Exhibit I  
BRODIE OAKS REDEVELOPMENT  
WATER QUALITY AND DRAINAGE

PUD CASE #: CD-2020-0002-BRODIE OAKS REDEVELOPMENT

### COMMENT REPORT

PROJECT NAME: Brodie Oaks Redevelopment

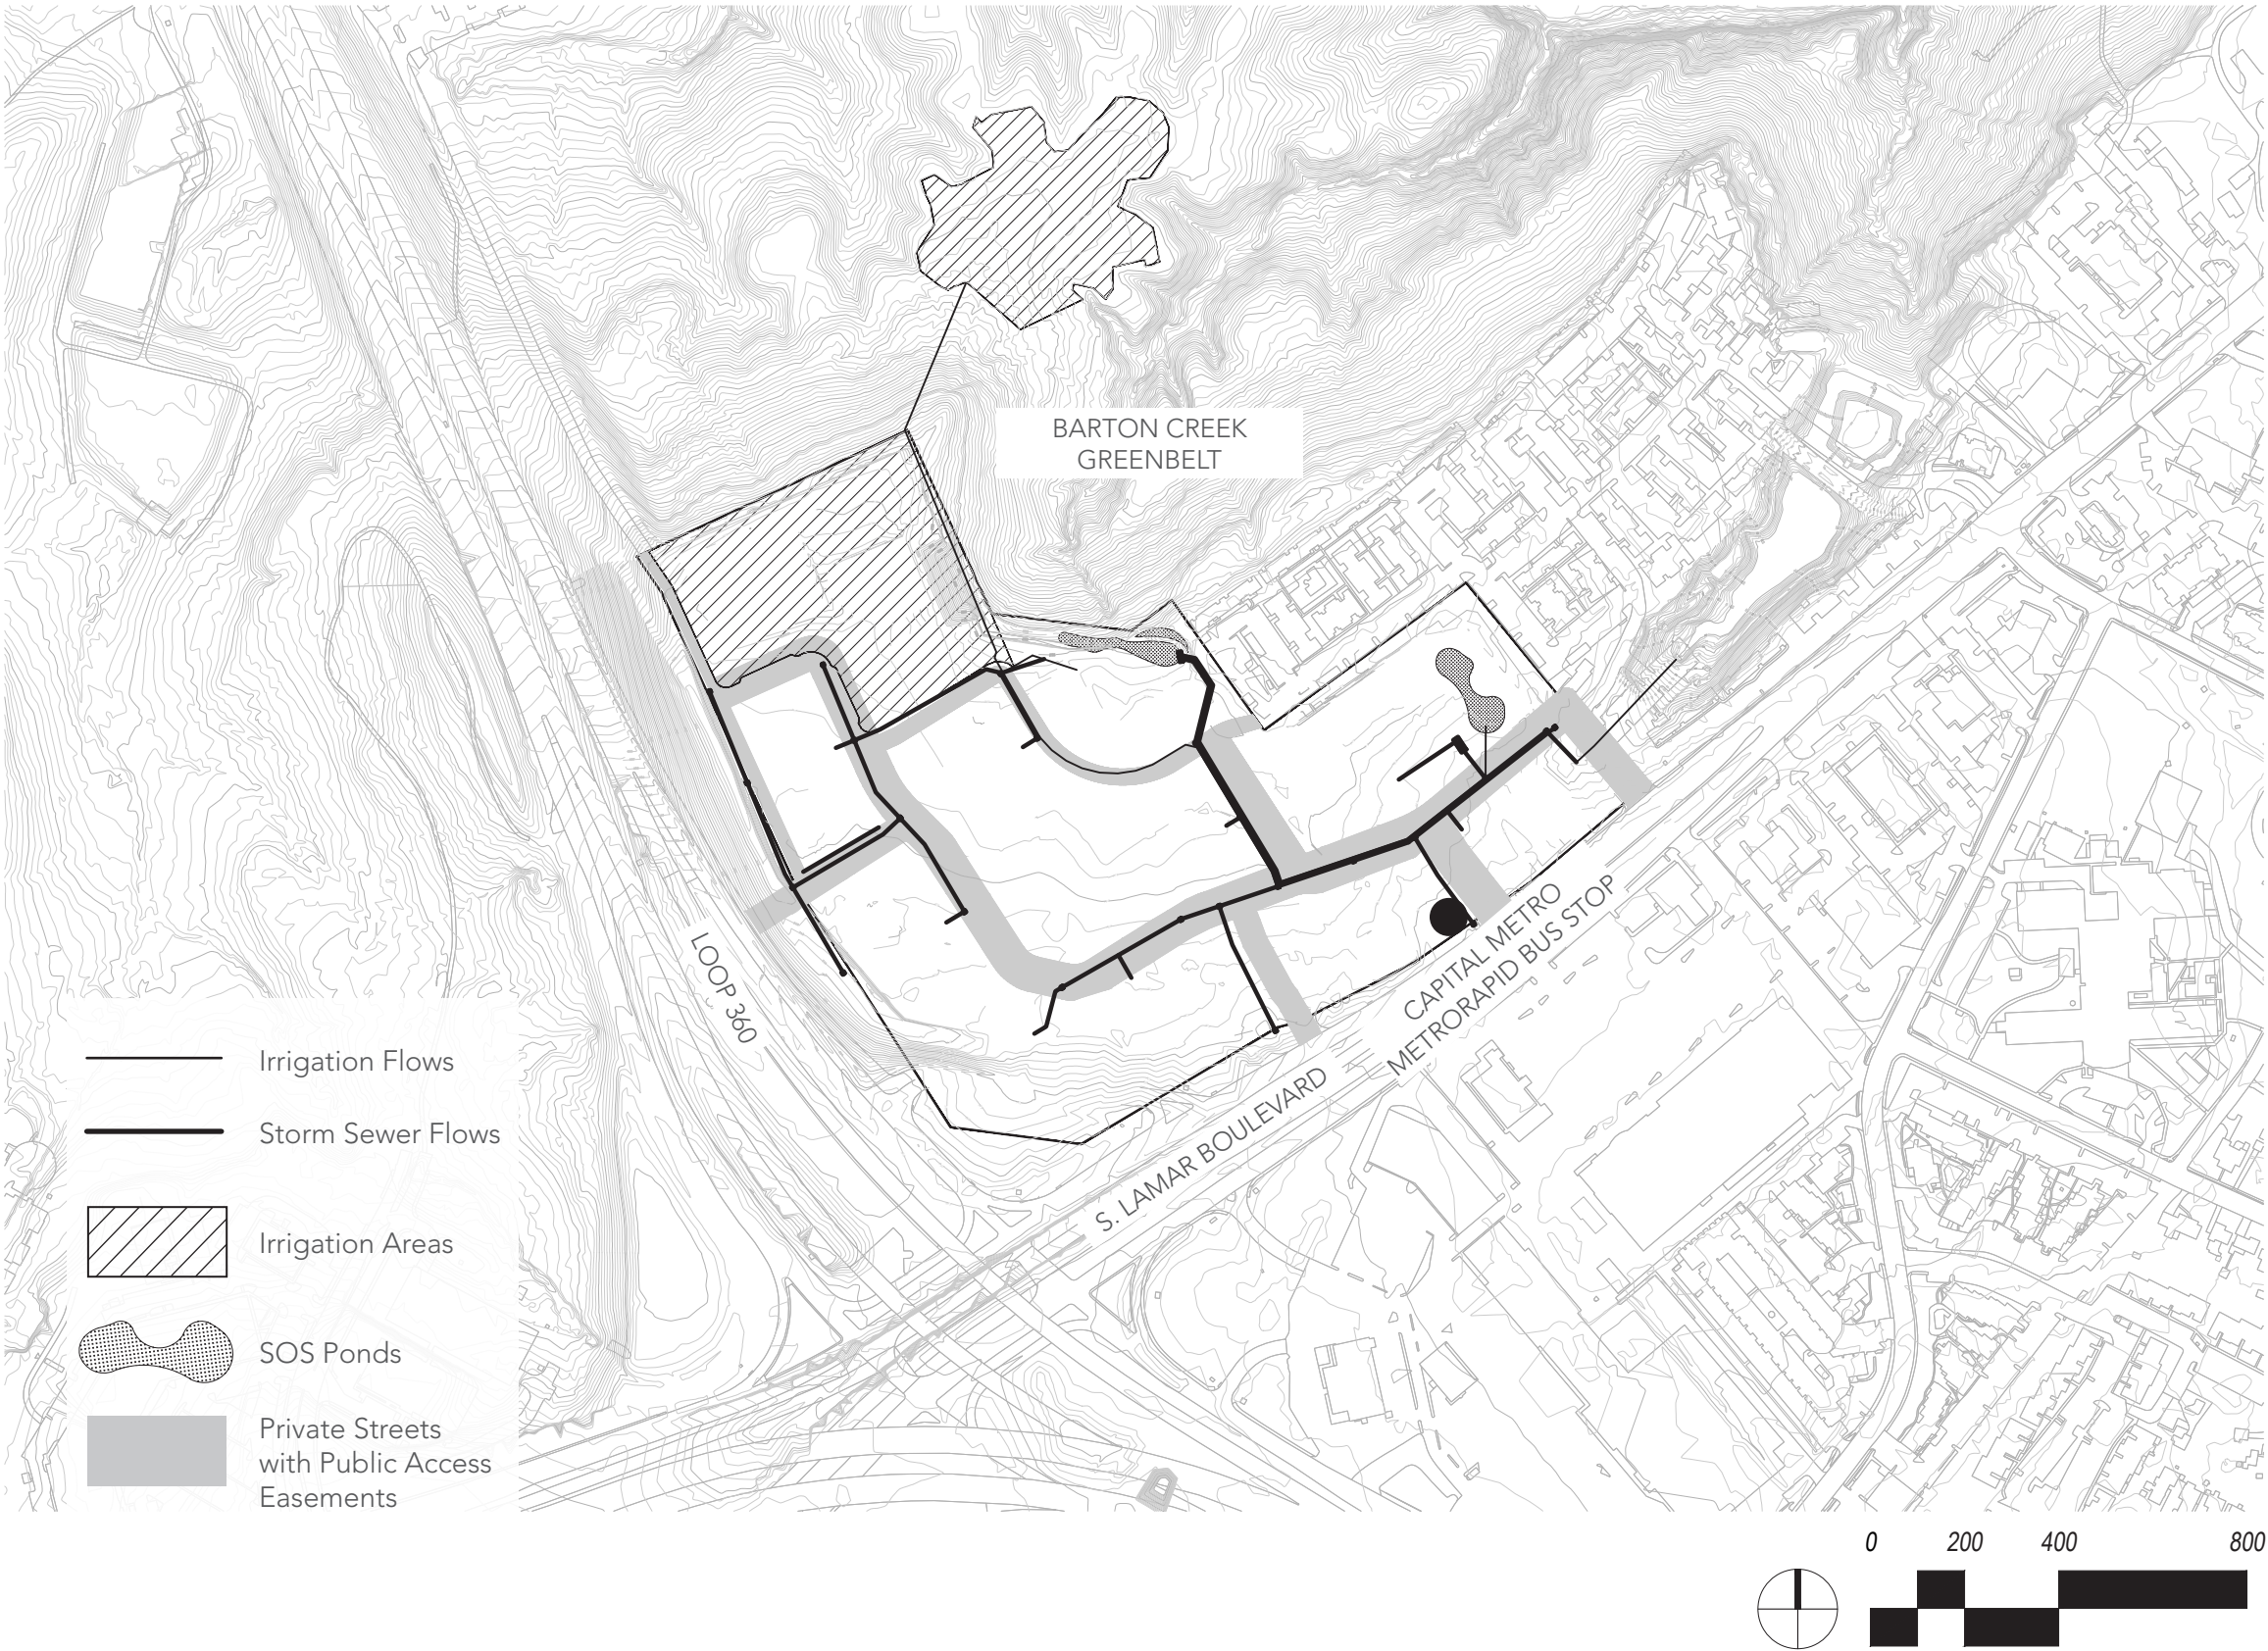
EV2. Environment/Drainage – Re-irrigation: the proposed plan for re-irrigation places the sprinklers in a natural area with highly erosive Del Rio clay soils that will compact and result in large sediment and debris running downgradient to the tributary and main channel of Barton Creek. In addition, the construction required for including this site element will disturb an area of the site that has not been disturbed throughout the life of the existing project. Staff strongly suggests relocating the re-irrigation areas and include a more innovative, integrated green storm water control facility in the proposed PUD.

- EV16. Exhibit C: In alignment with comment EV 7, this comment is pending for Land Use Plan Note #2.
- EV17. Exhibit F: In alignment with comment EV 2, this comment is pending additional information to be provided as resolution for placement of the re-irrigation areas.

# Exhibit J **BRODIE OAKS REDEVELOPMENT GRADING PLAN**

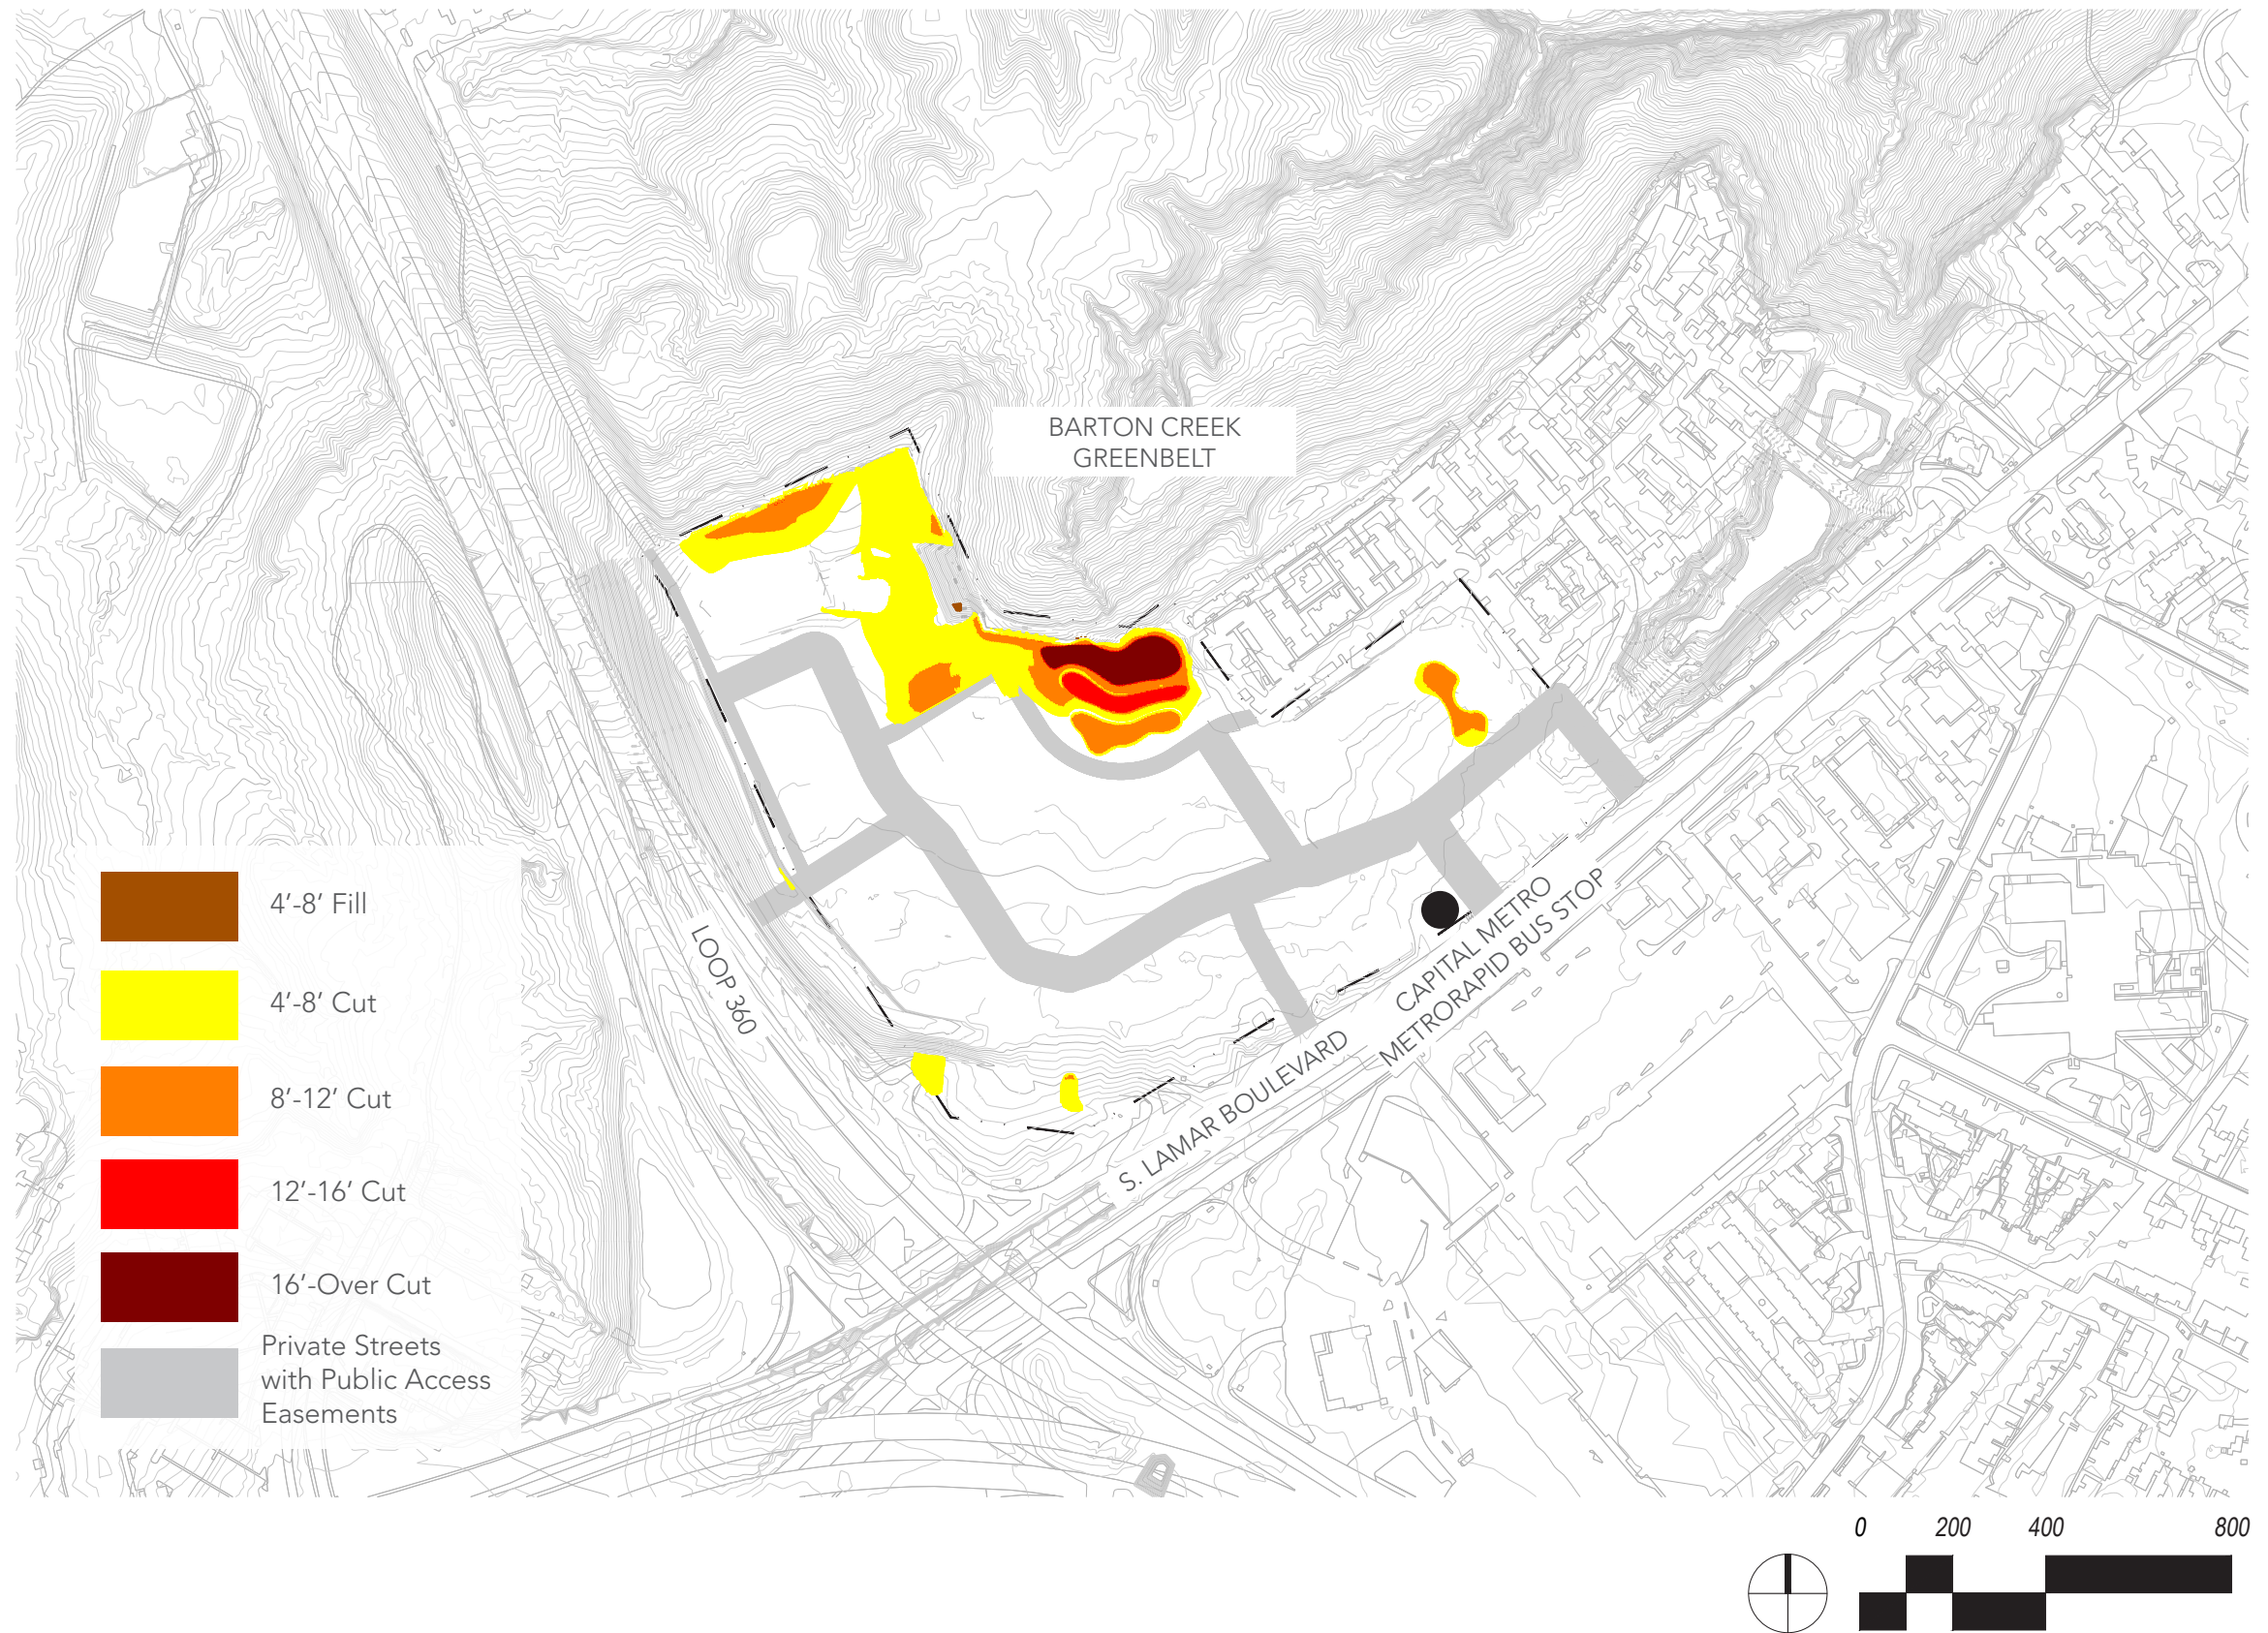
- CA 9. Exhibit G – Grading. For those areas of cut and fill proposed greater than four feet, please provide additional information and clarification on the overall disturbance of these requests and the trees potentially impacted in these areas. This request goes toward reviewing the PUD's overall tree preservation effort.
- CA 10. Trees proposed to be preserved must be shown with a continuous circle.

- EV18. Exhibit G: In alignment with comments EV 10 and EV 11, provide callouts or show more detailed information on the plan in order for Staff to fully determine if the proposed grading exceeding four feet in depth meets compliance with current code requirements and exceptions.

Parks must be designed to properly function as parks. Currently, the Trailhead Park appears to consist mostly of ponds in the Grading Plan. Please revise the Grading Plan so that there is more evenly-graded, unencumbered parkland, or show in the park development plan how the parks will function given the constraints of the ponds. Likewise, the grading of the Overlook Park has cuts of over 12 feet. Is this also for drainage? Parks must be evenly-graded in order to meet parkland dedication standards.
